# Annual Monitoring Report

## Little Pine Creek II

### Monitoring Year 2 of 7

Subject: RE: Draft MY02 Monitoring Report  
Little Pine Creek II Mitigation Project, Alleghany County  
DMS Project # 856  
DEQ Contract #LP082819

**Table 12. Verification of Bankfull Events  
Little Pine Creek II Stream and Wetland Mitigation Site/Project No 856.**

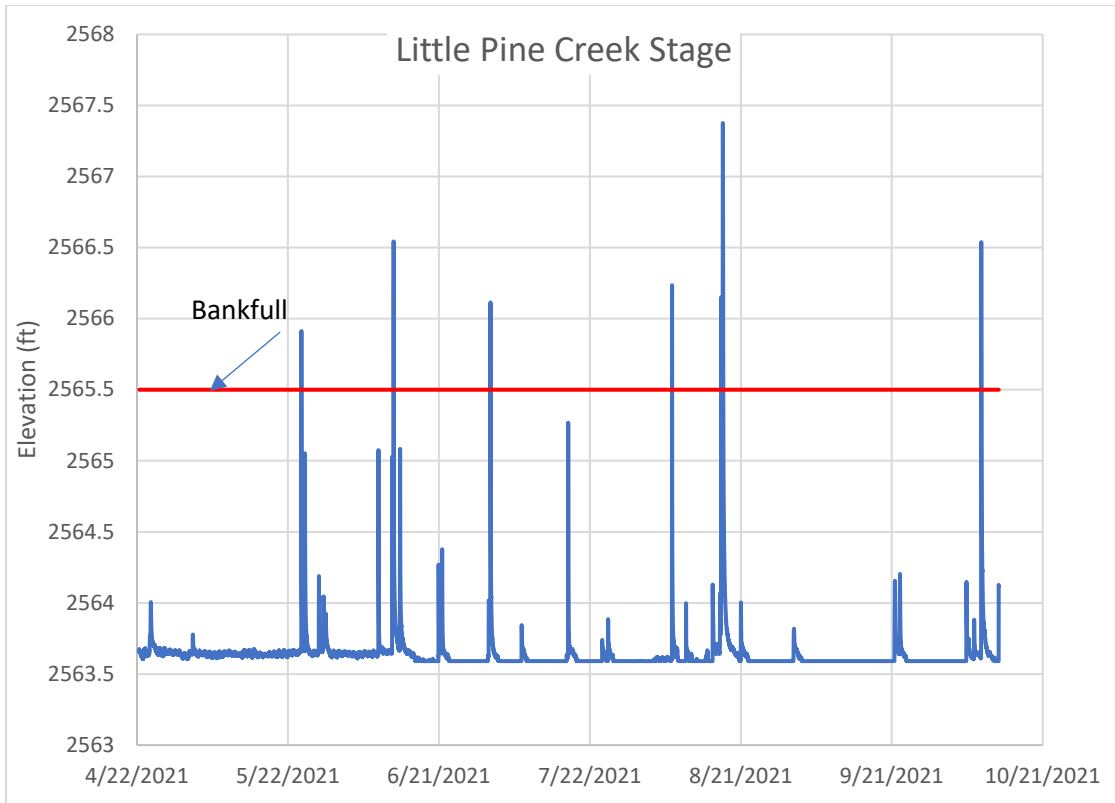
- *The report overall is clear, accurate and error free, DMS appreciates EWS's efforts on the project and report.*
- *Please add a footnote to Table 12 (bank full events) indicating that the multiple listed dates for 2021 (and represented by the same photo) were based on precipitation and stage recorder data were recorded over the specified time period. **Footnote added.***
- *If possible please include one photo each of the three scoured/eroded "areas of concern" on LPC (110+25, 120+75, and 121+50). DMS has observed these recently as well and will continue to assess them over time. **Photos and descriptions added to Appendix B.***
- *Vegetation – please indicate that DMS is currently under a 4-year contract to manage and treat the various small pockets of invasive vegetation. **Text added.***

+ The multiple listed dates for 2021 are based on precipitation and stage recorder data from January thru October, 2021
